From:
Sent: 09 March 2026 12:59
To: DC Admin
Subject: 2025/60/93572/E - objection - FAO E Thornhill

I am writing to raise further concerns regarding the above planning application, specifically in relation to the access details that have been submitted.

I am writing to raise further concerns regarding the above planning application, specifically in relation to the design and access statement and the Park Lane arrangements that has been submitted

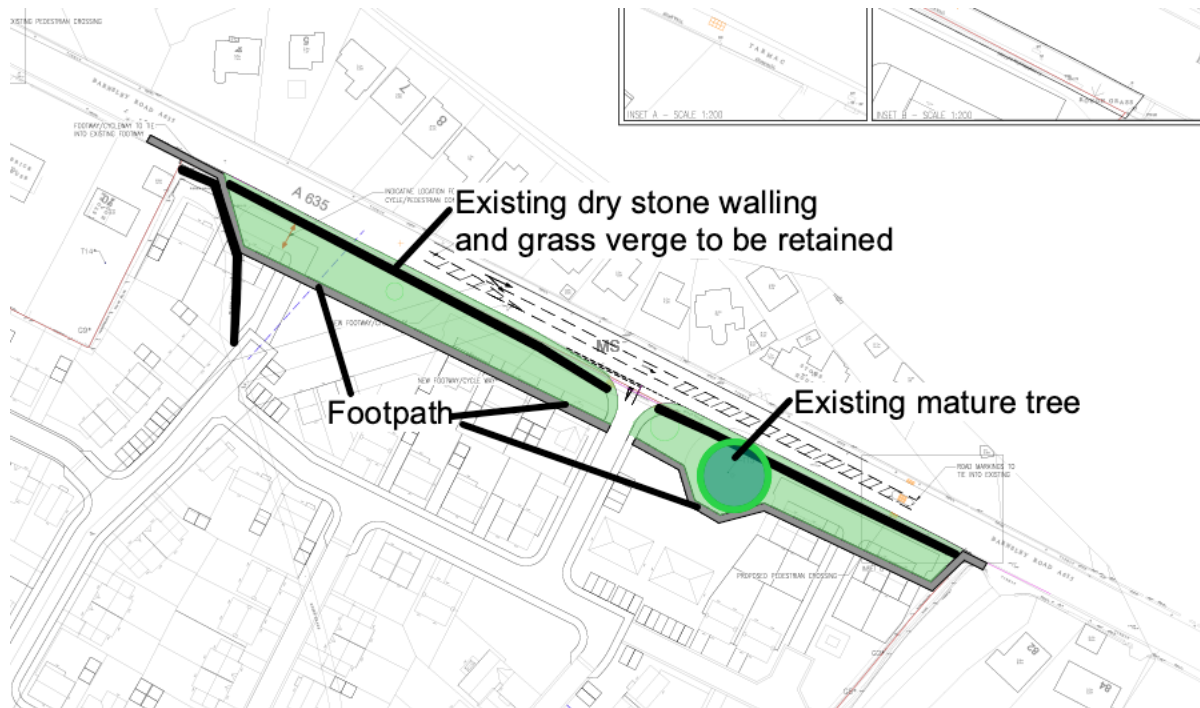
Although I have already lodged an objection to the application, a closer review of the submitted access drawings highlights several discrepancies between what is shown on the plans and the existing site conditions on the ground.

The field currently benefits from grass verges and traditional drystone walling along the boundary with Barnsley Road, both of which contribute significantly to the rural character of the area. In addition, there is an approximate level change of around 1 metre between Barnsley Road and the field itself. These existing features appear to have been disregarded within the submitted access plans.

The drawings appear to indicate that the drystone walling and grass verge would be removed or omitted entirely to facilitate the proposed access. Such an approach would be wholly inappropriate in this location. The retention of the drystone walls and grass verges is essential in order to preserve the established countryside character of the roadside frontage.

Furthermore, the protection and retention of the existing ecological network must be a key consideration, particularly given that the site lies within the Green Belt. The removal of these boundary features would have a detrimental impact on both the visual amenity and ecological value of the site.

For clarity, the extract below demonstrates how the access arrangement should reflect the existing on-site conditions.
